Certificate of Appropriateness

BAR # 24-09-01

409 Park Street, Tax Map Parcel 530037000

Project: Fence [Request change to Administrative CoA approved July 8, 2024.]

409 Park Street - fence. July 8, 2024 (rev 1)

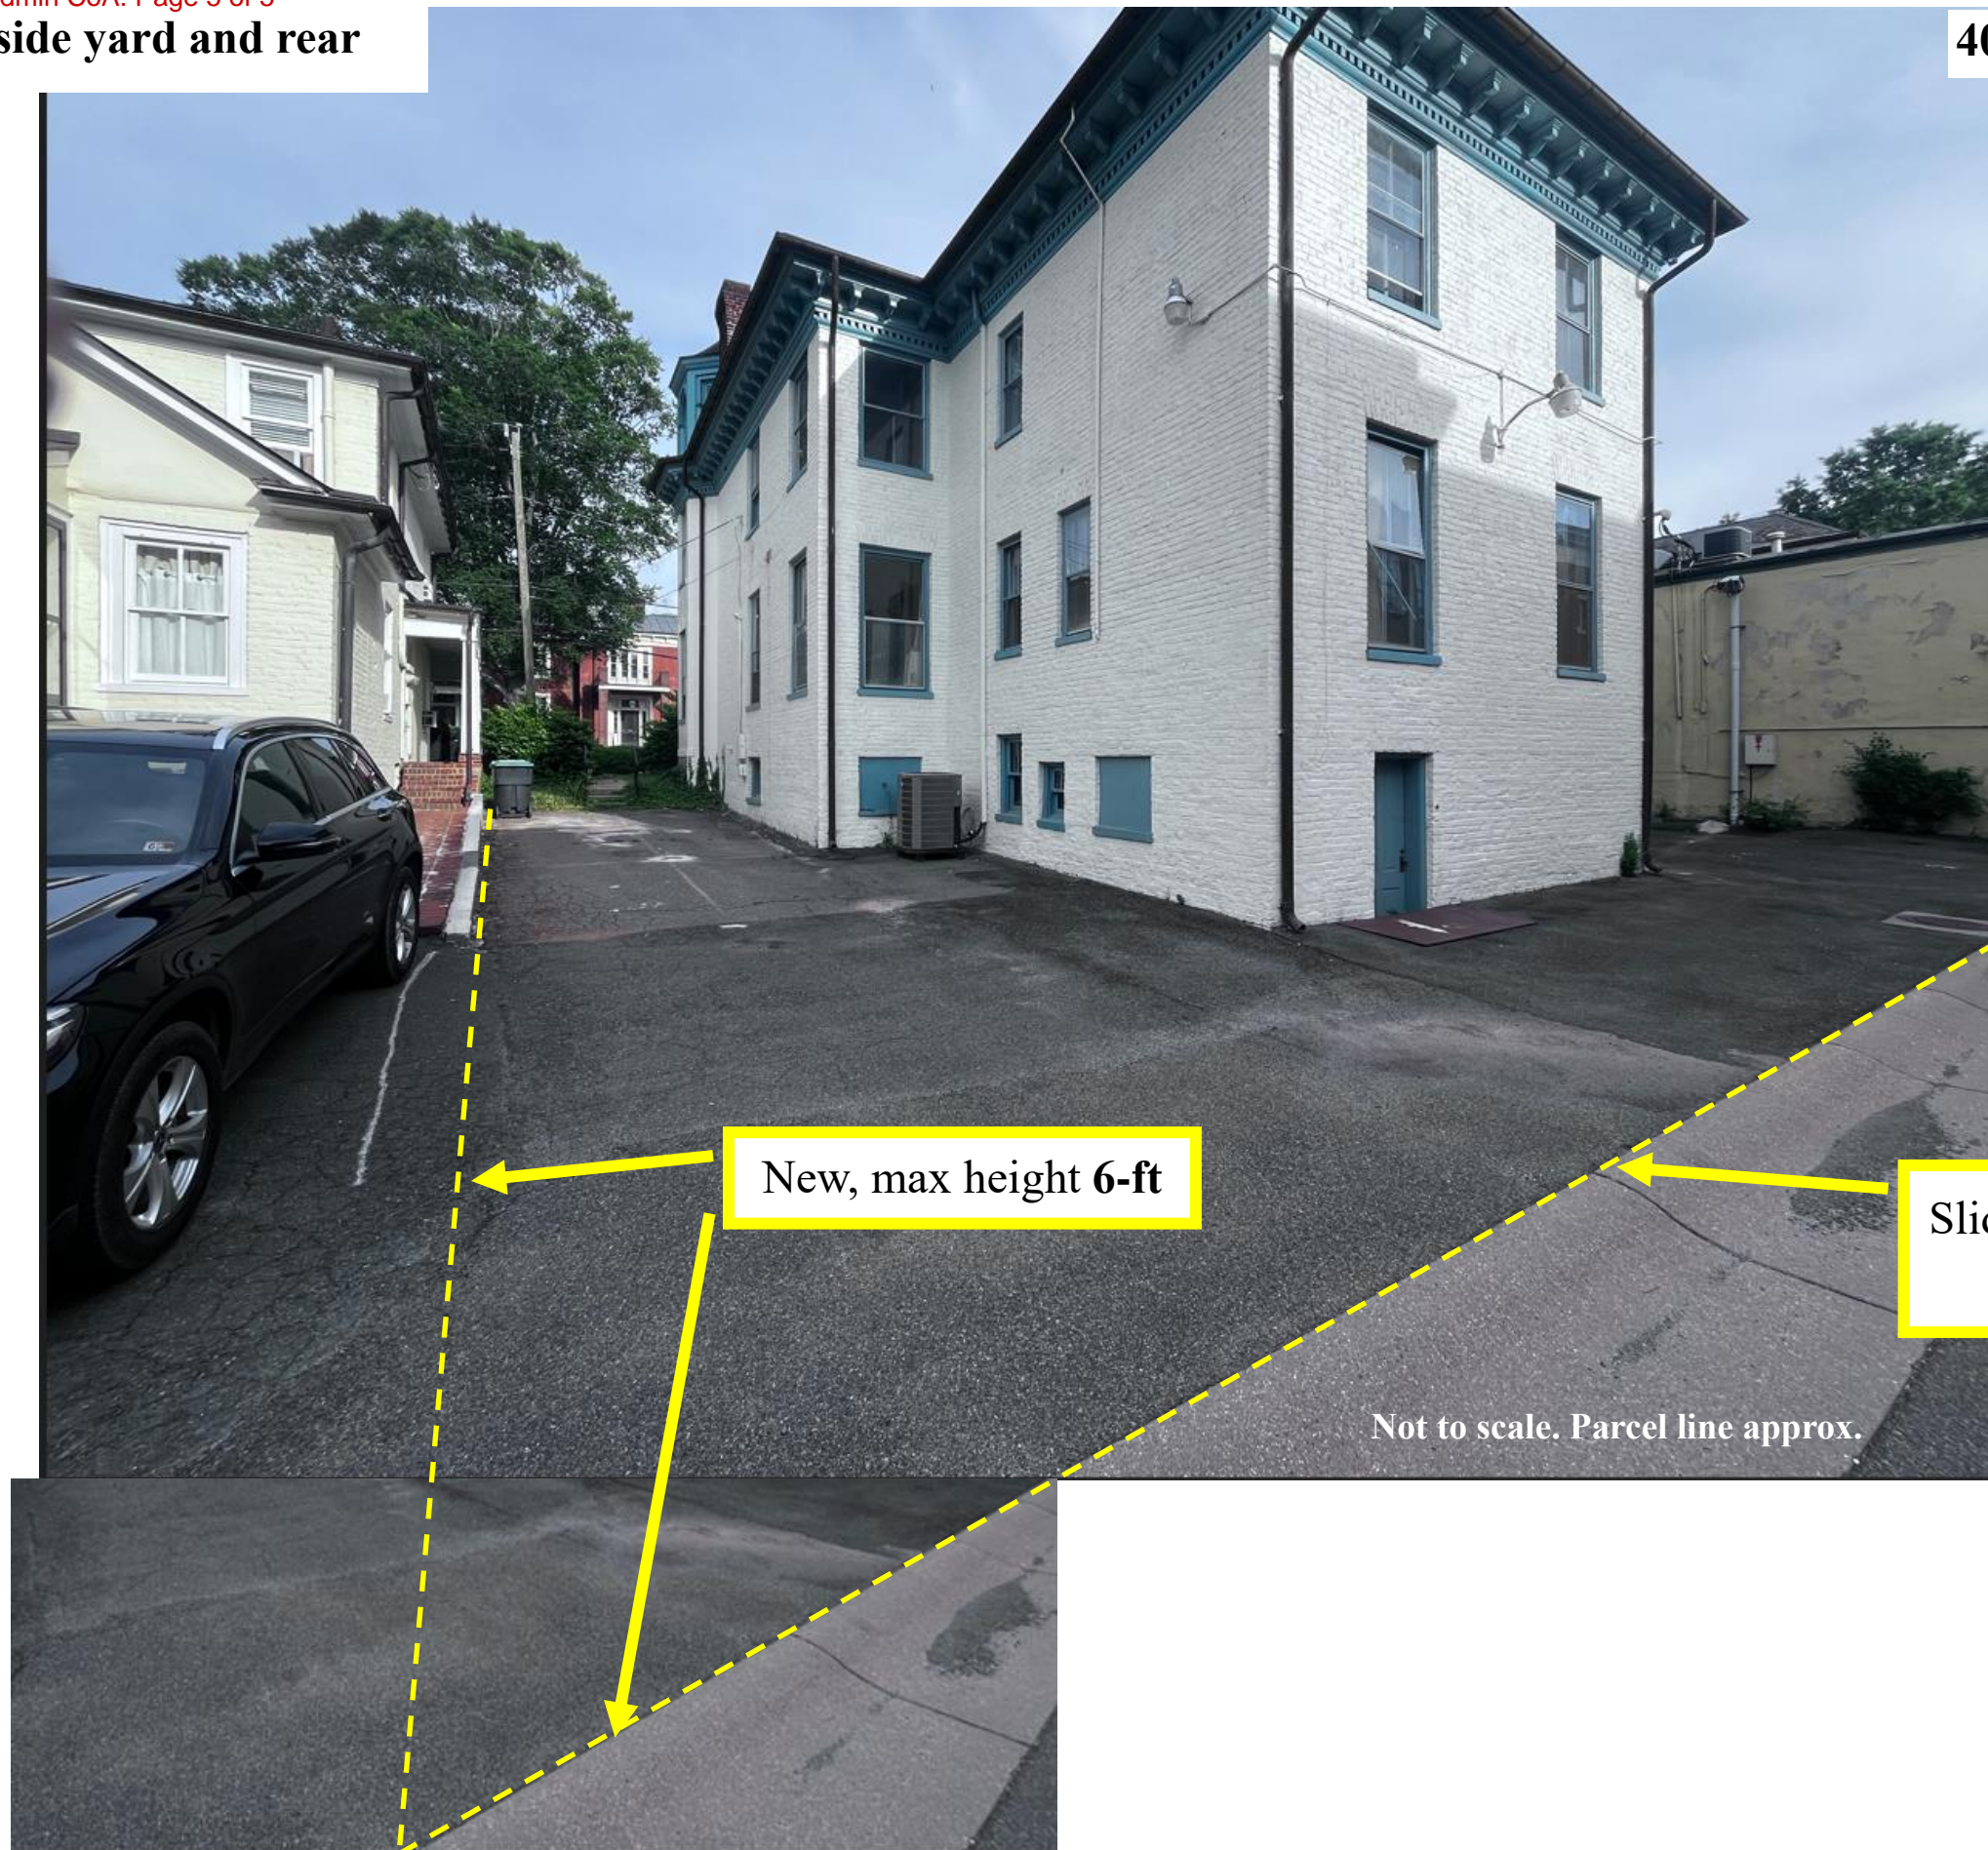
During construction and following completion of this section, staff informed the applicant the fence at the SE corner must not be taller than the historic fence. Following completion, the applicant stated the fence complied with the CoA because while the new segment was taller where it met the historic fence, the height was no taller than other, non-adjacent sections of the historic fence. Staff was unwilling to allow the change; however, the applicant was invited to submit an application requesting the BAR allow it.

From staff email to the applicant, August 19, 2024: "... I noticed the posts and rails along the south boundary had been constructed taller than the historic metal fence."

From staff to the applicant, August 27, 2024: “Your contractor installed the fence too high on the south side, so it will have to be reworked.”

- Front yard: not higher than historic metal fence.
- Side yard: max height 4-ft.

Having considered the standards set forth within the City Code, including the ADC District Design Guidelines, approval of a CoA for the height of the painted wood fence at 409 Park Street, as currently constructed on the south side satisfies the BAR's criteria and is compatible with this property and other properties in the North Downtown ADC District, and that the BAR approves the request *with the recommendation* to cut the last post down to be level with the rest of the fence.
